## **ADDENDUM NO. ONE**

ORANGE BEACH SEWER DEPARTMENT OFFICE BUILDING  
ORANGE BEACH, ALABAMA

ADDENDUM NO. ONE (1) – DATED APRIL 30, 2020

**ROOF FRAMING PLAN**  
 SCALE: 1/4"=1'-0"  
 TOP OF MASONRY = +16'-8" U.N.O. = JOIST BEARING

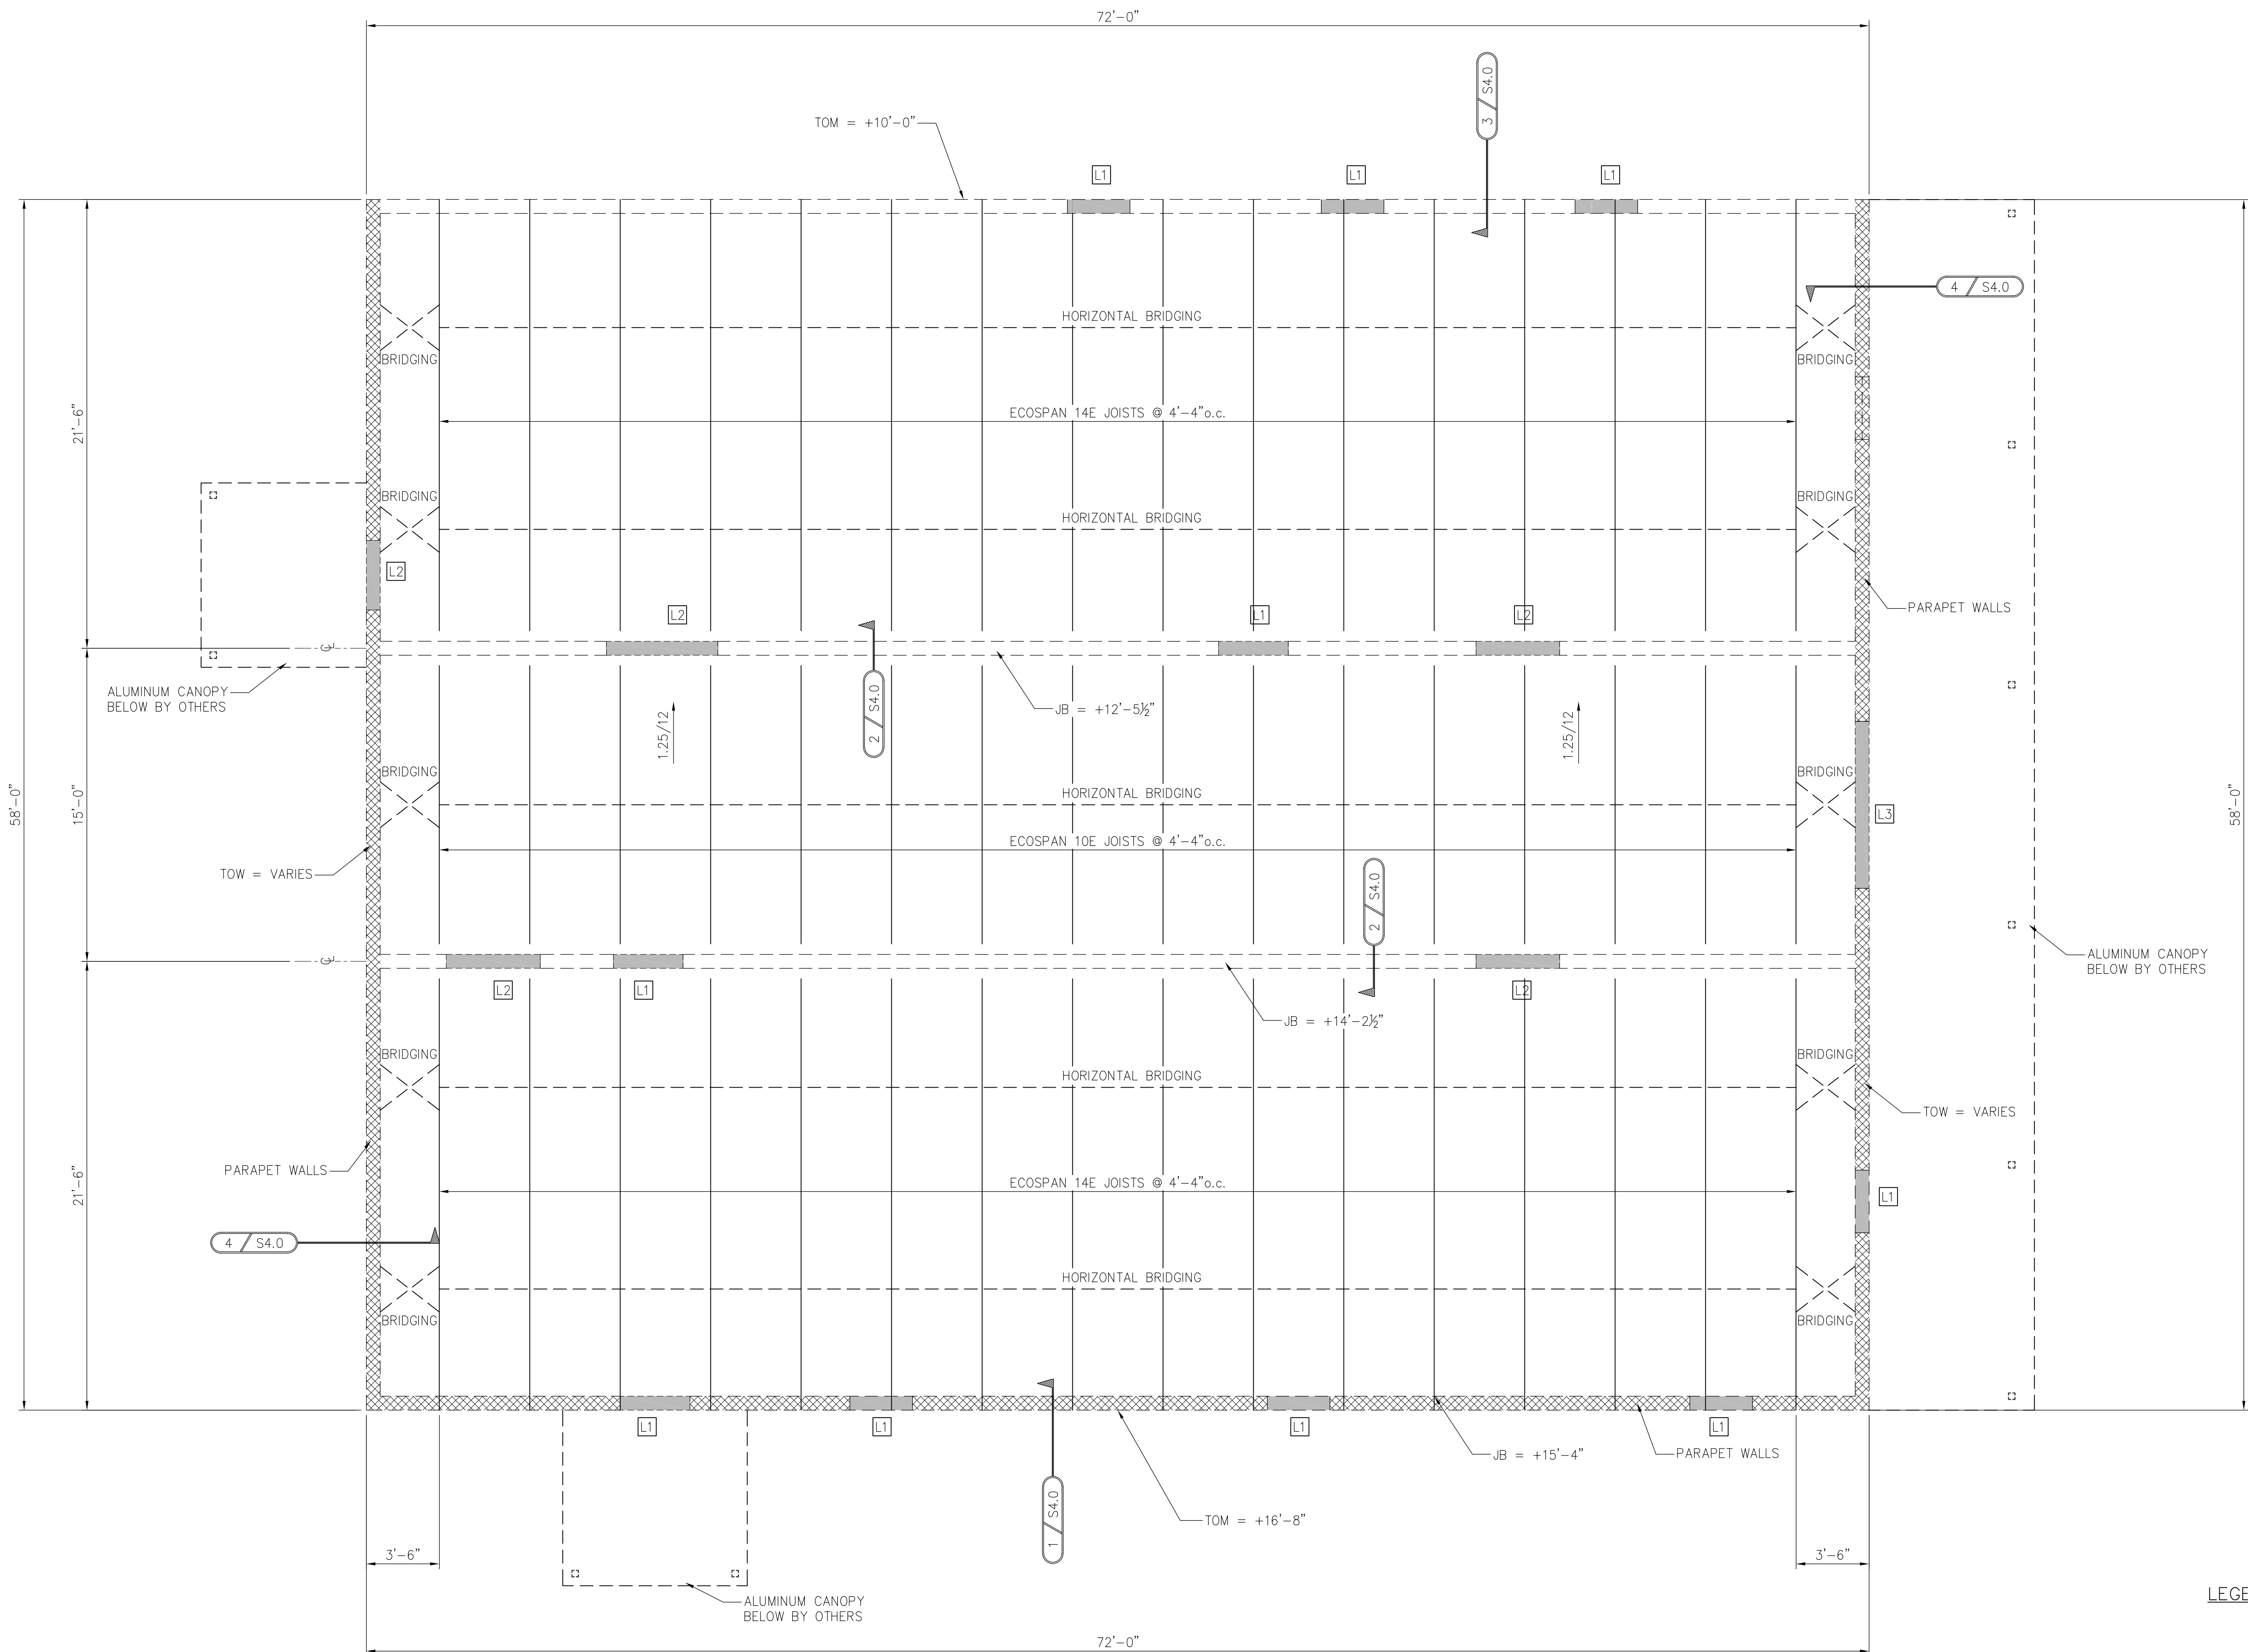
**1. Sheet S0.0, S1.0, S2.0, S3.0, S4.0 – ATTACHED**

- a) Please see attached revised structural drawings and note that in addition to other changes indicated, all masonry cells are to be grout-filled.
